# Service Bulletin

Bulletin No.: P11020

**Subject:** Rattle/Squeak Noise and/or Rear of Center Console Loose

**Models:** 2013 Cadillac ATS  
Vehicles Built Prior to May 10, 2013

3449043

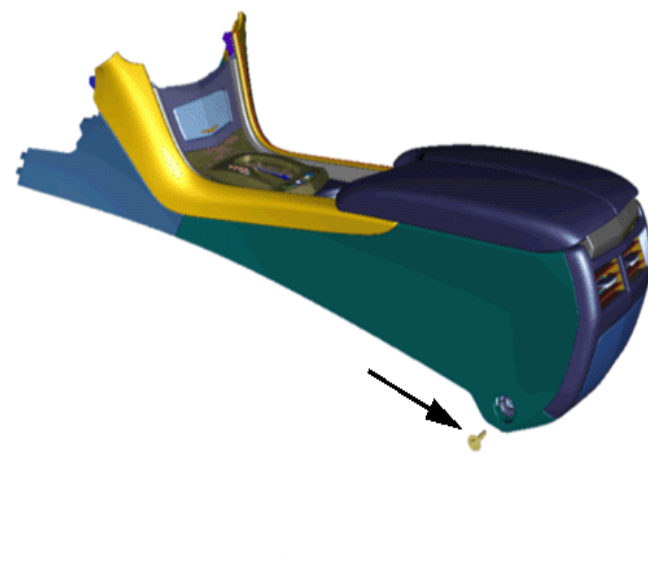
Some customers may comment on a squeak/rattle type noise heard and/or the rear center console may be loose. This may be due to a design change with the rear of the center console that may cause the two rear attaching bolts to bottom out before being fully secured.

**Note:** (1) is the bolt used during production, (2) is the revised bolt being used

Replace both the right and left rear side console bolts, as shown in the illustration above, with the revised bolt listed in the Parts Information below. **DO NOT** replace the front console bolts. They are not affected.

Tighten the bolts 9 N•m (80 lb in).
